**ADDENDUM TO RFP DOCUMENTS**

ADDENDUM # 03
	SCCD RFP: # 14-014
	Project: Solano Community College District Theater Renovation
	Date: 08/13/2015

**Addendum # 03 – The following clarifications are provided based on questions received and must be added/considered when completing your submittal:** Acknowledgement of receipt of this **ADDENDUM** is required in the proposal’s cover letter of introduction. Please clearly note the addendum date and number.

**A2.11**

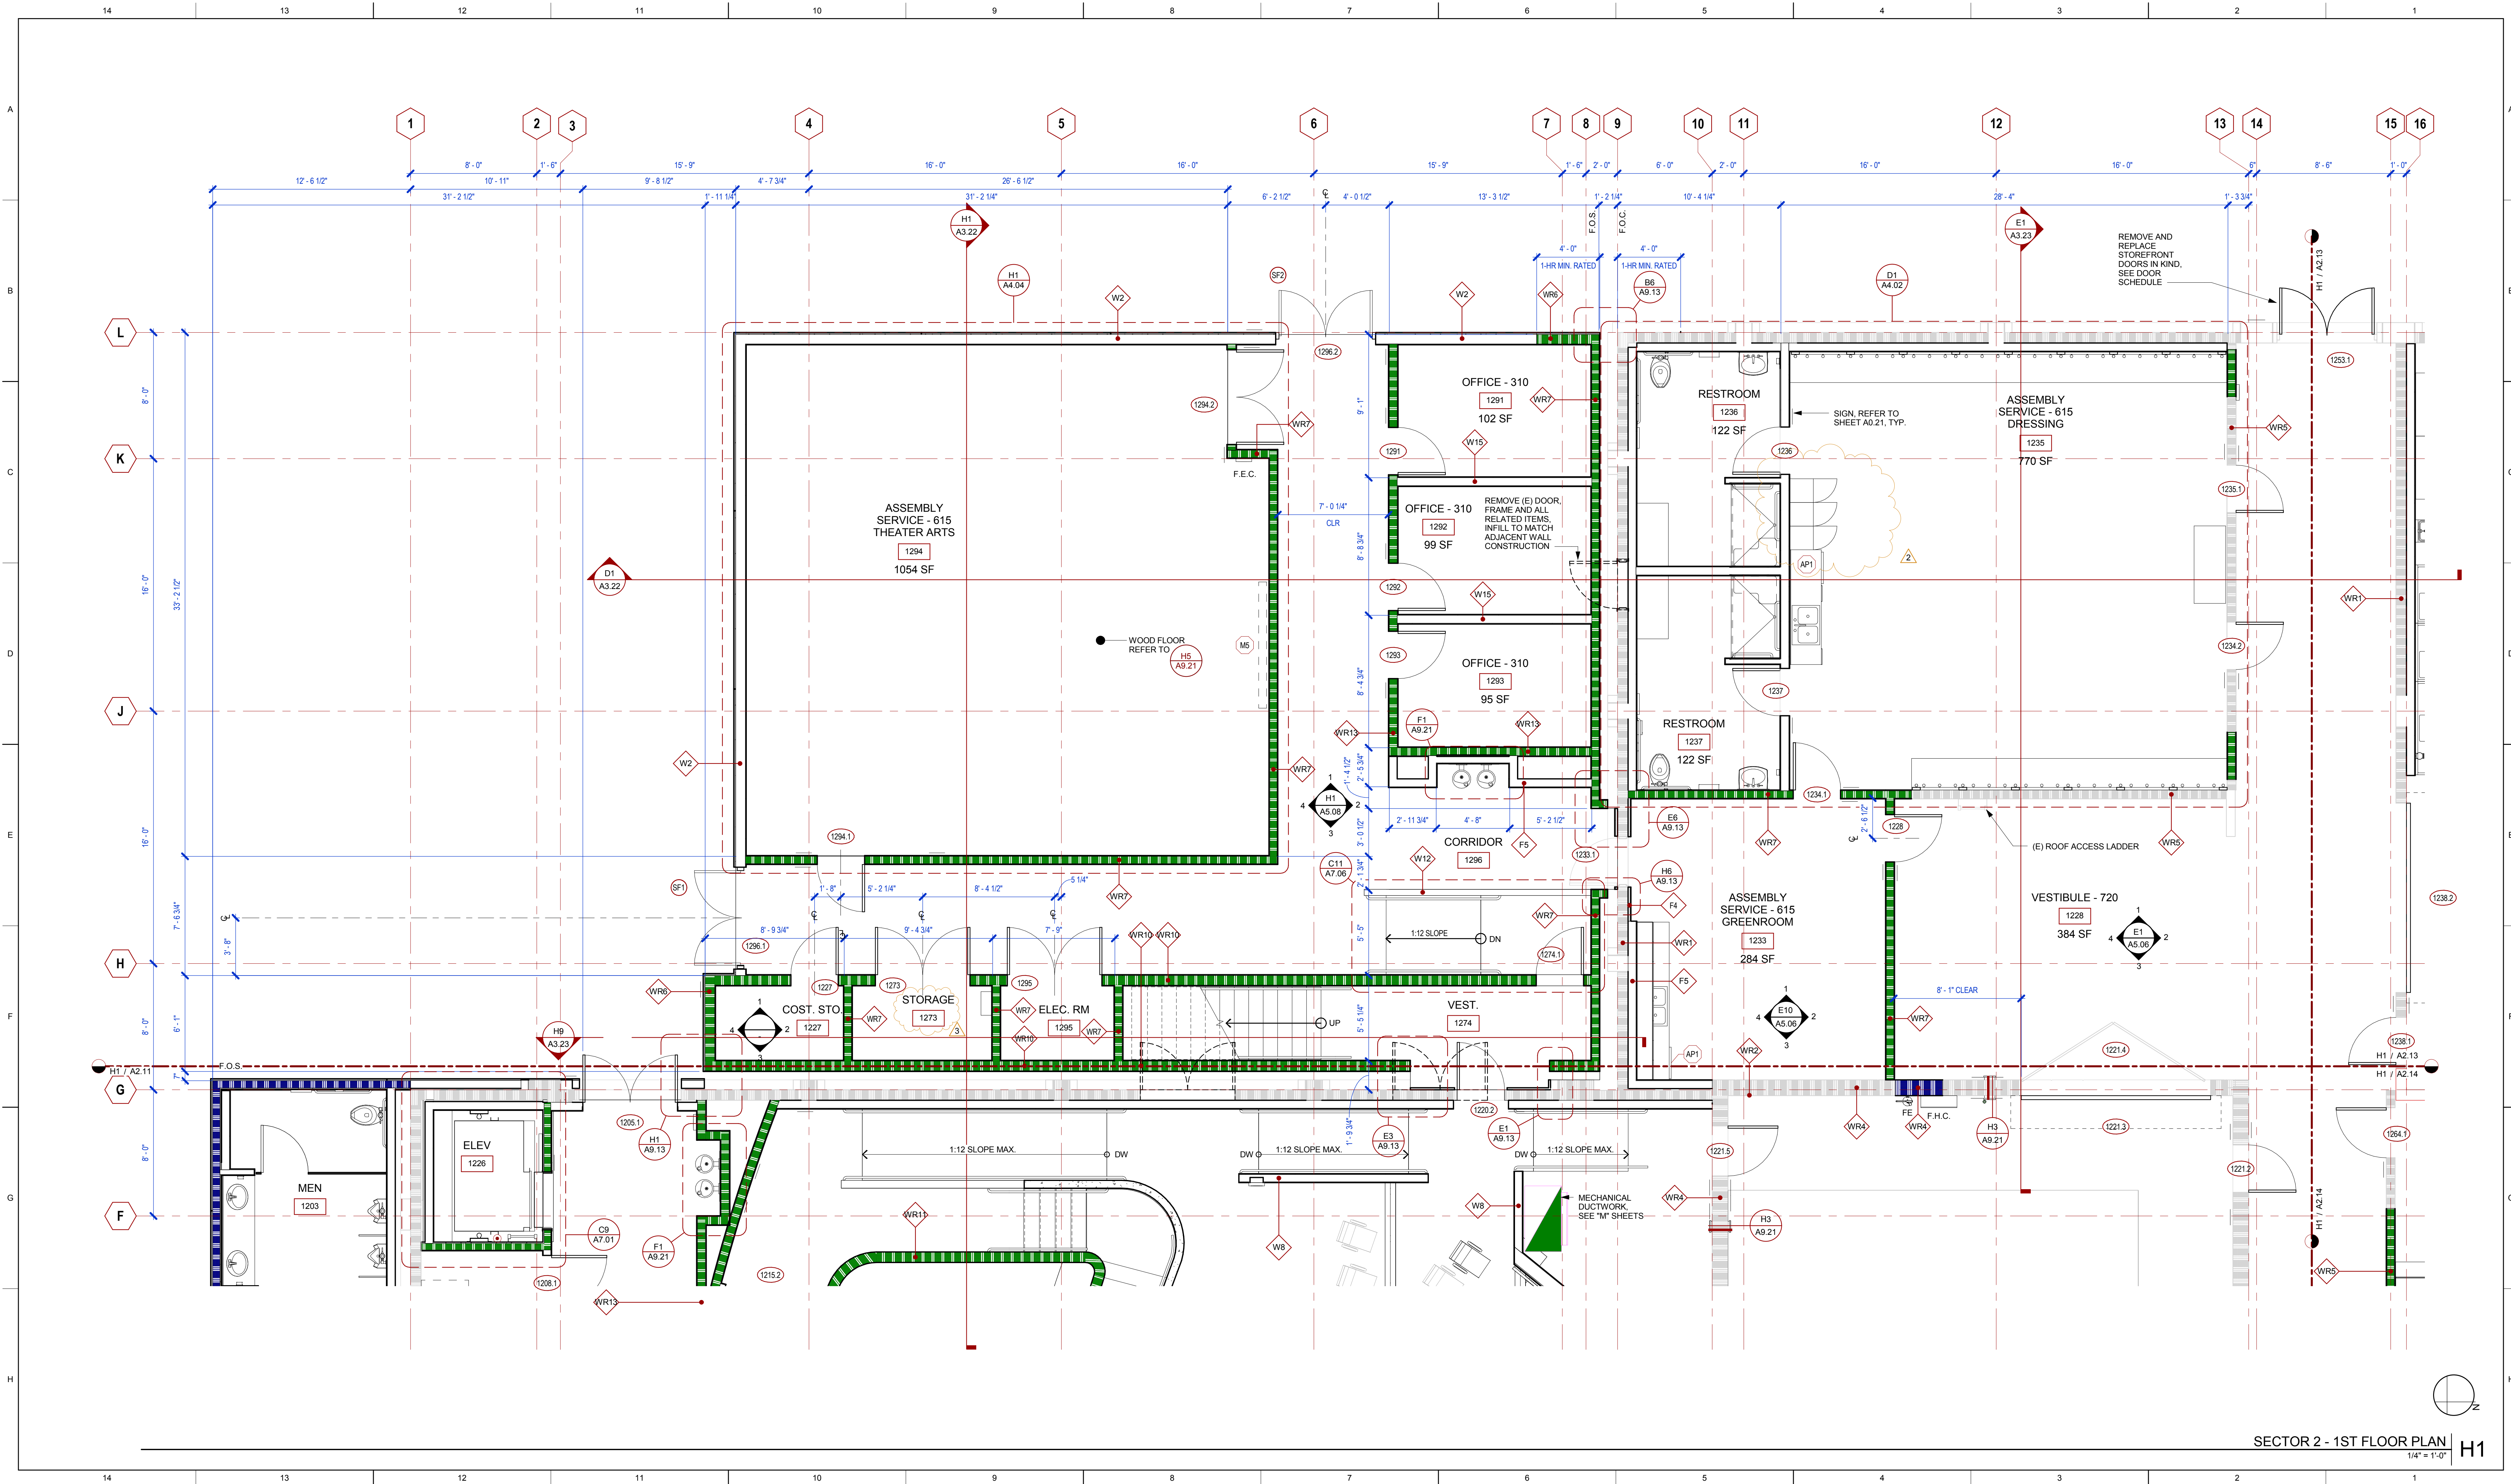
1. Sheet A2.11
  - Moved ELEVATOR EQUIPMENT ROOM 1273 to new location adjacent to CUSTODIAL ROOM 1211, and changed room number to 1219
  - Added door 1219
2. Sheet A2.12
  - Change ELEVATOR EQUIPMENT ROOM 1273 to STORAGE ROOM 1273.
3. Sheet A2.60
  - Added WALLCOVERING TYPES WC4 and WC5. Both are add alt #1 only.
4. Sheet A2.61
  - In CORRIDOR 1296 added WC5
  - In CORRIDOR 1225 added WC4

# A2.61

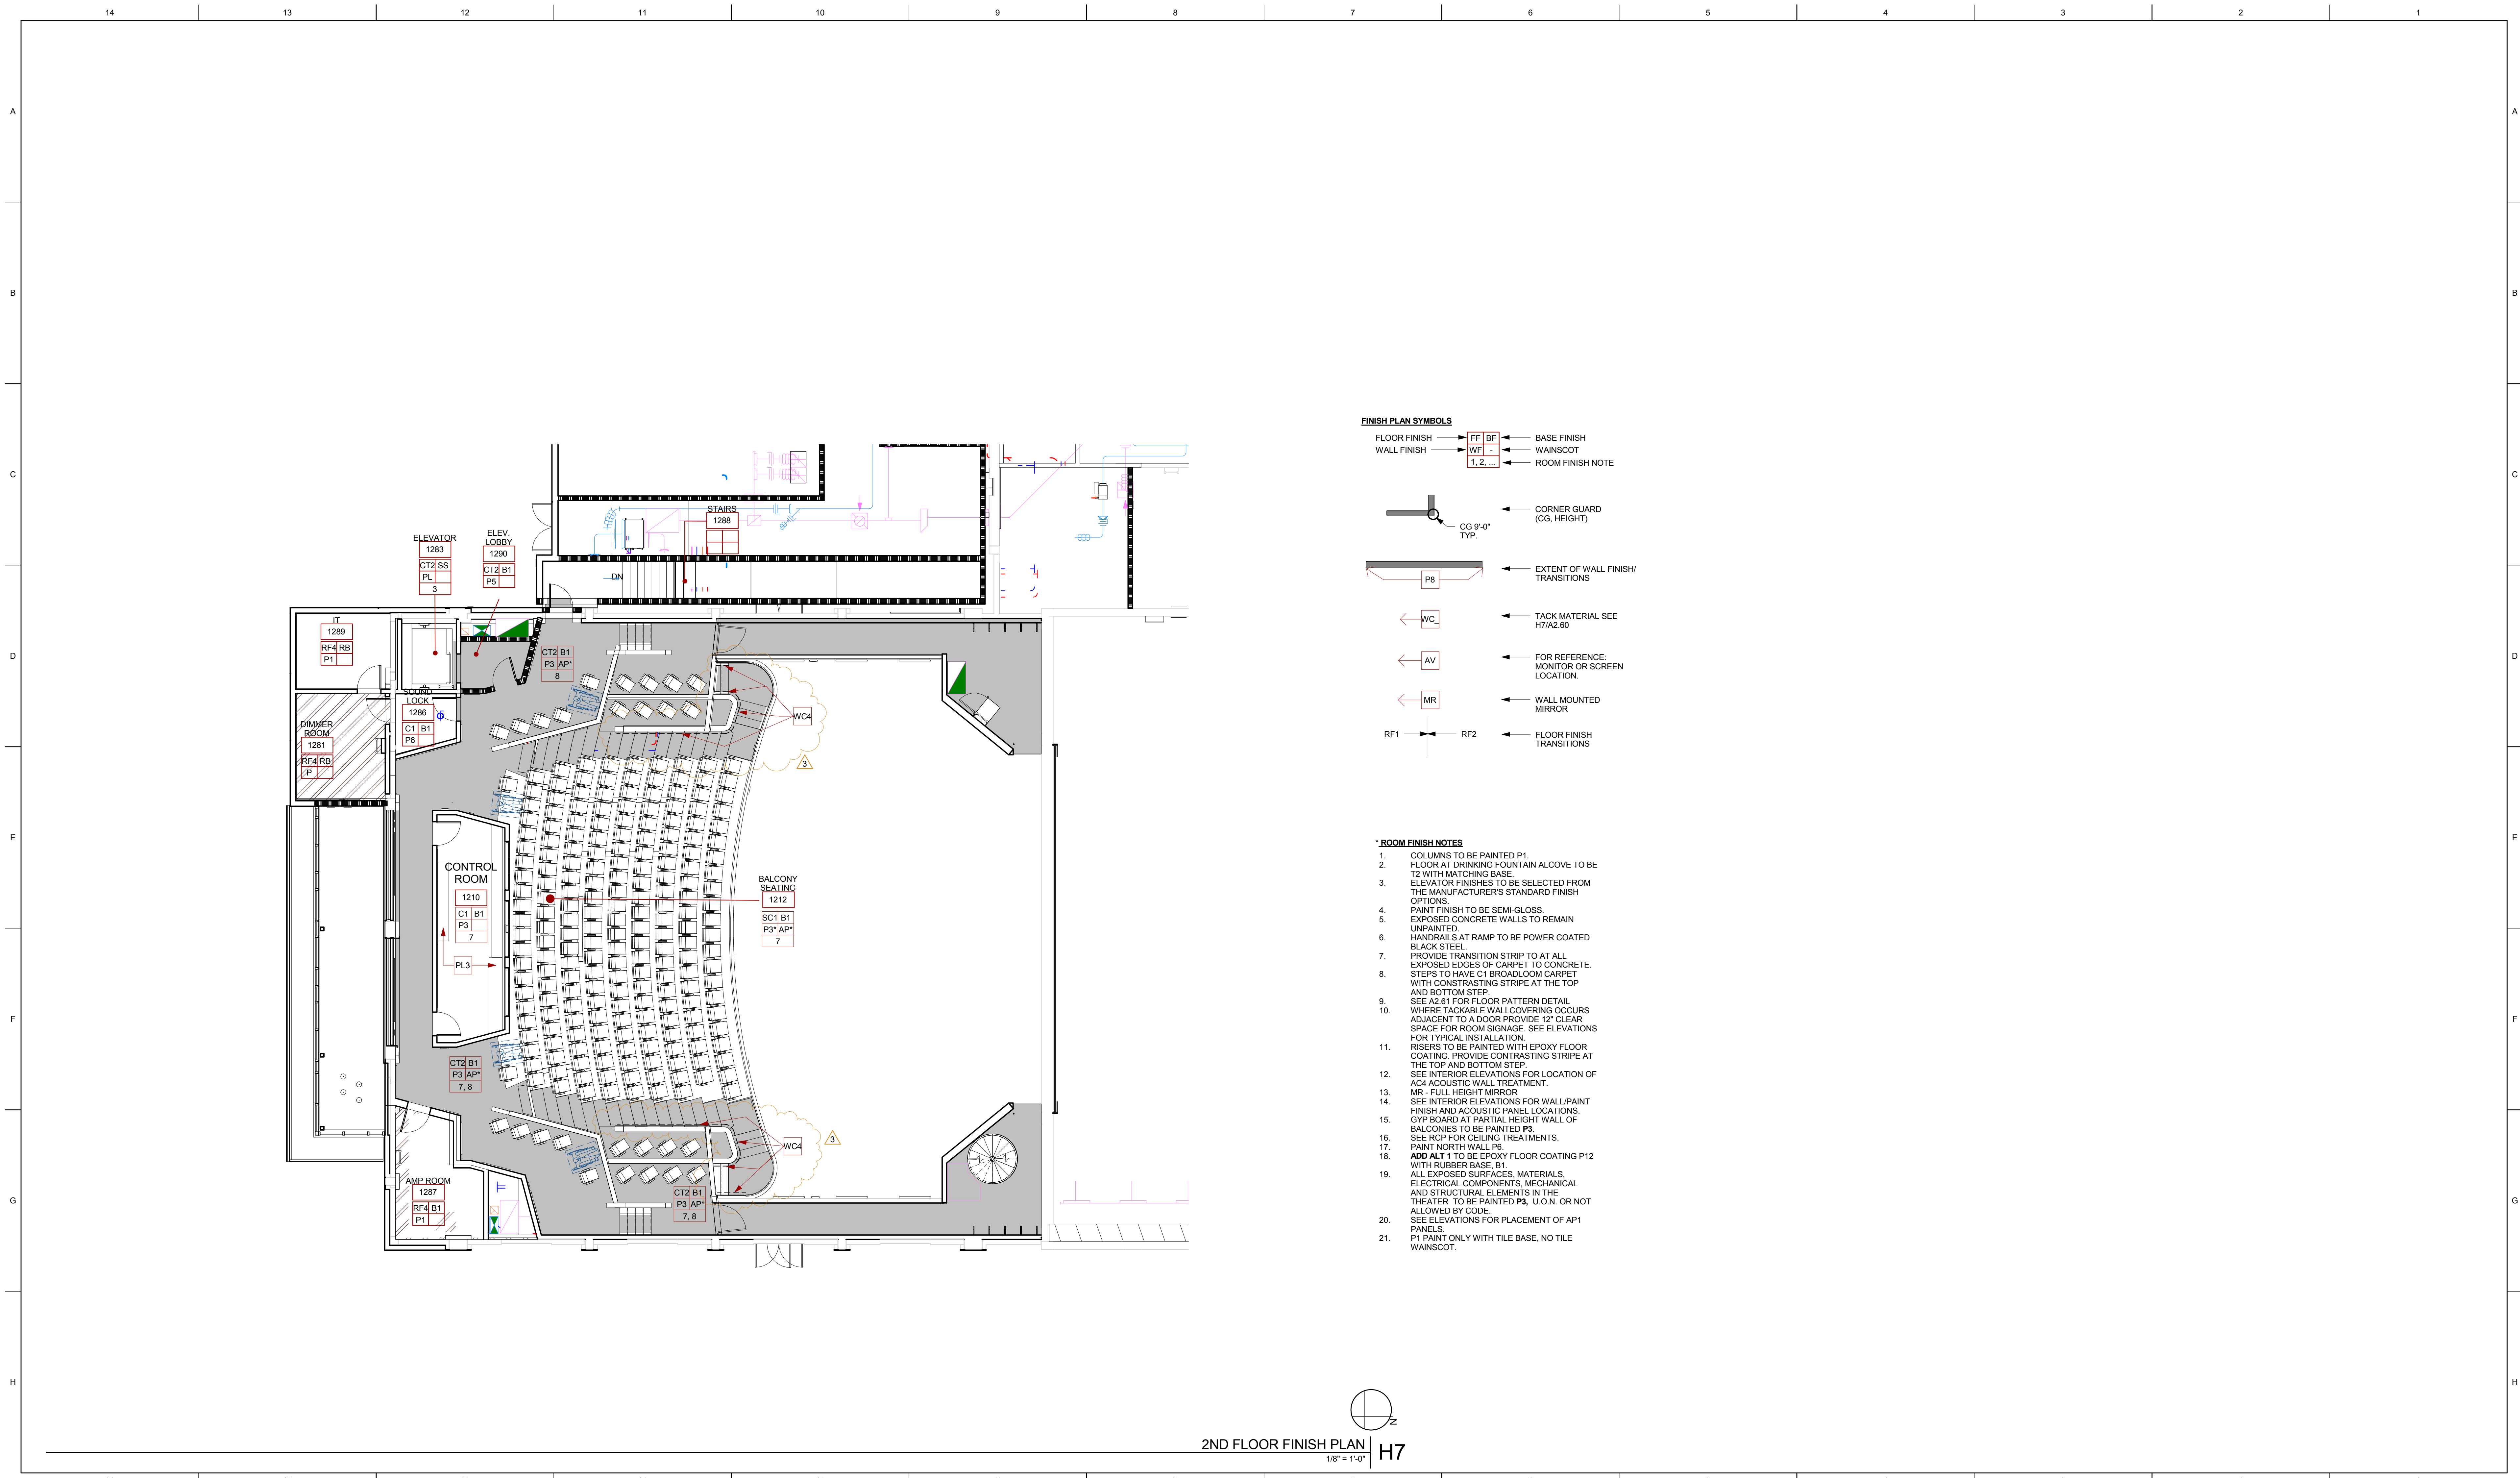
- In CORRIDOR 1224 added WC4
  - In CORRIDOR 1254 added WC5
5. Sheet A2.62
- On left and right hand sides of BALCONY SEAT 1212 added WC4.
6. Sheet A2.81
- On door 1227 changed hardware group from 14 to 10.
  - On door 1253.3 changed;
    - Door type to (E)
    - Door material to (E)
    - Frame type to (E)
    - Frame material to (E).
7. Sheet A9.55
- Revised details B4, B6, D4, D6, F4 AND F6. Details were changed to remove timely knockdown type to standard heavy-duty hollow metal with fully welded frames.
8. Sheet A3.22
- Revised building section H1 at ELEVATOR EQUIPMENT ROOM 1219.
9. Sheet M2.2
- Added fire smoke damper to practice room 1261 in the 10x10 supply duct.
